## 7.6 All Other Instrumentation Systems Required for Safety

The information in this section of the reference ABWR DCD, including all subsections, tables, and figures, is incorporated by reference with the following departures and supplements.

Figure 7.6-4a Basic Configuration of a Typical Neutron Monitoring System Division

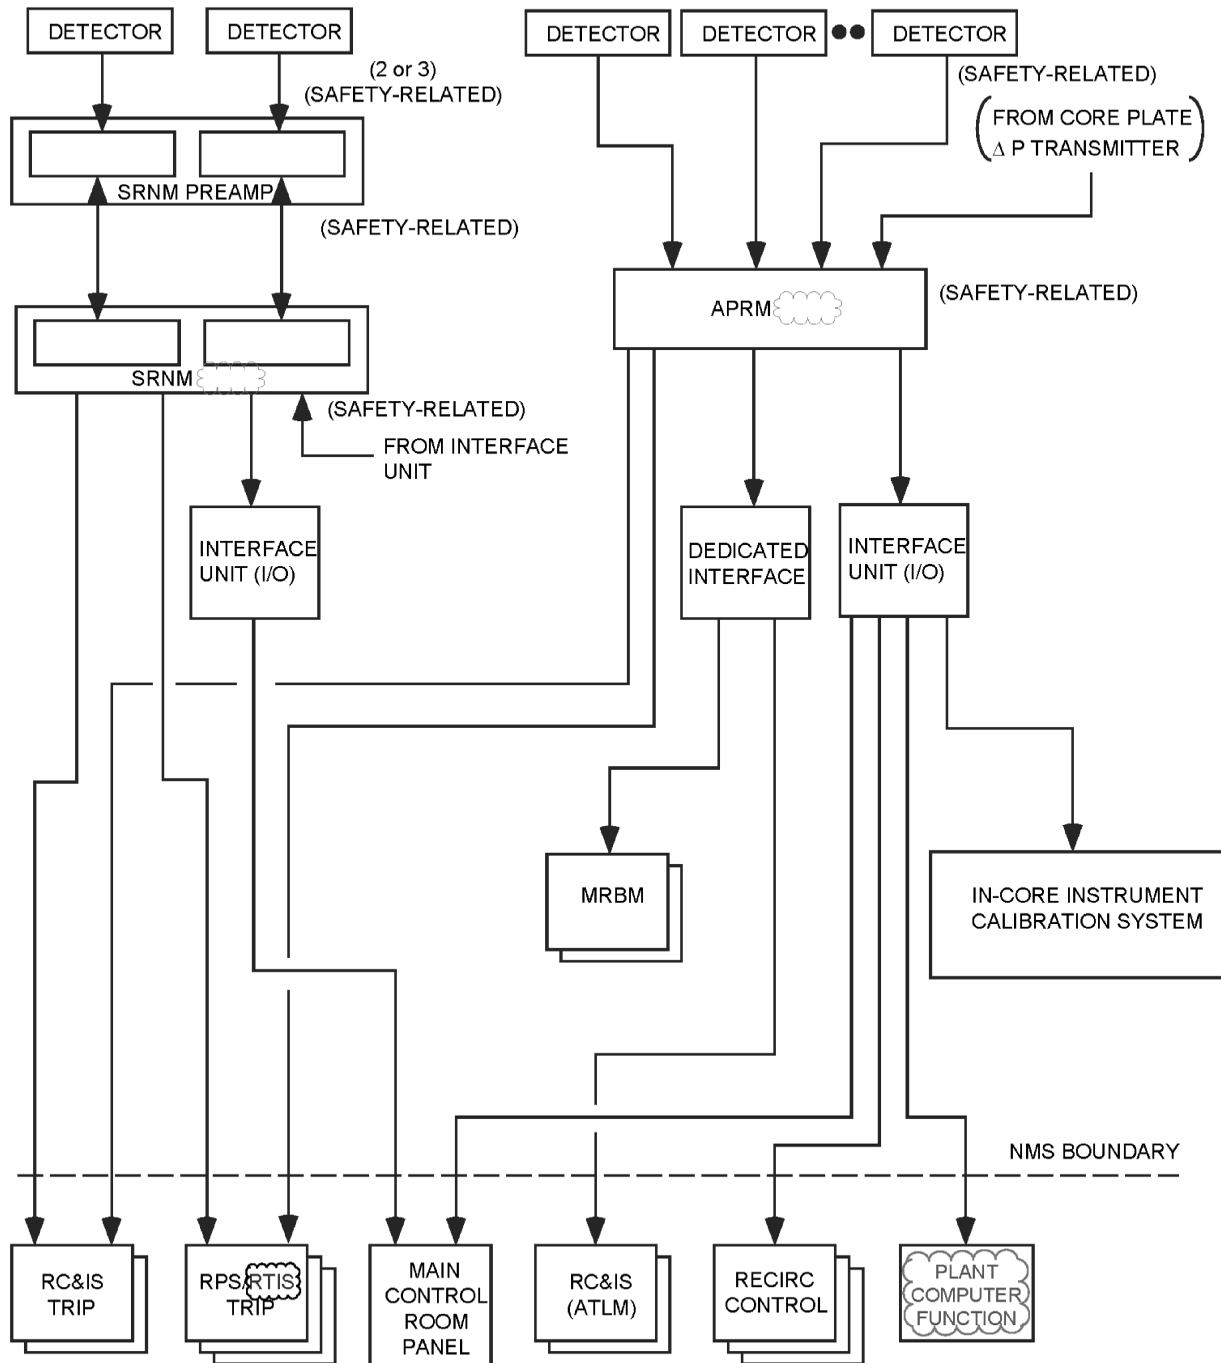
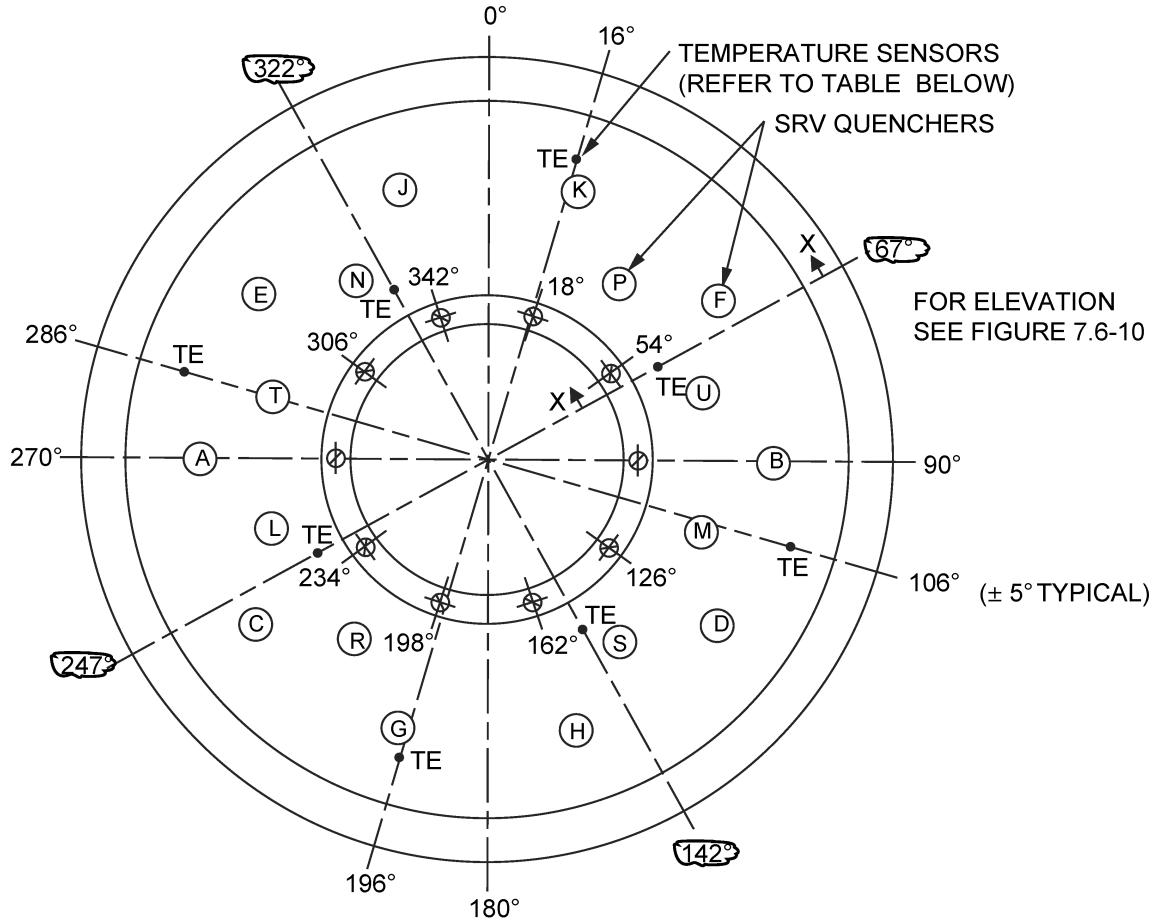
STD DEP T1 3.4-1 (Table 7.6-5 and Figures 7.6-1, 7.6-2, 7.6-4a)

*The purpose of the Neutron Monitoring System (NMS) is to monitor power generation and, for the safety function part of the NMS, to provide trip signals to the Reactor Protection System (RPS) to initiate reactor scram under excessive neutron flux (and power) increase condition (high level) or neutron flux fast rising (short period) condition. The NMS also provides power information of operation and control of the reactor to the Plant Process Computer System (PCS) Functions (PCF) and the rod block monitor. A block diagram showing a typical NMS division is shown in Figure 7.6-4a. The operating ranges of the various detectors are shown in Figure 7.6-4b.*

Figure 7.6-14 OPRM Logic

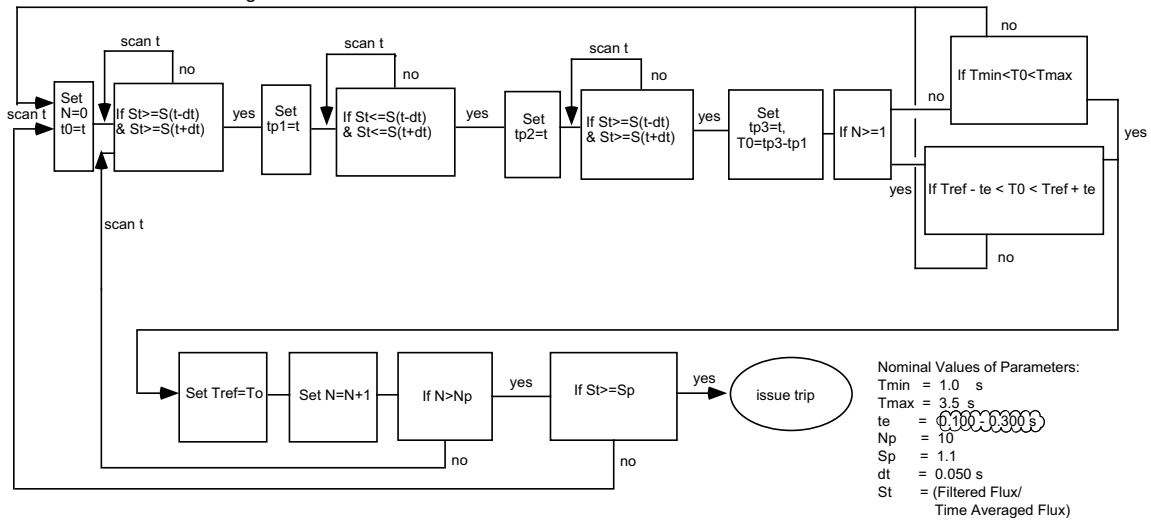
STD DEP 7.6-1 (Table 7.6-2 and Figures 7.6-2, 7.6-14)

*For the OPRM trip function, the response signal of any one OPRM cell that satisfies the conditions and criteria of the trip algorithm will cause a trip of the associated OPRM channel. Figure 7.6-14 illustrates the trip algorithm logic. ~~The OPRM trip function does not have its own inoperative trip for insufficient number of total LPRM inputs in the channel. It follows the APRM's inoperative trip of insufficient number of LPRMs.~~ The OPRM function has its own inoperative trip when the channel has less than the required minimum operable cells, when there is an OPRM self-diagnostic fault, when the APRM instrument watchdog timer has timed out, or if there is a loss of power to the APRM instrument.*
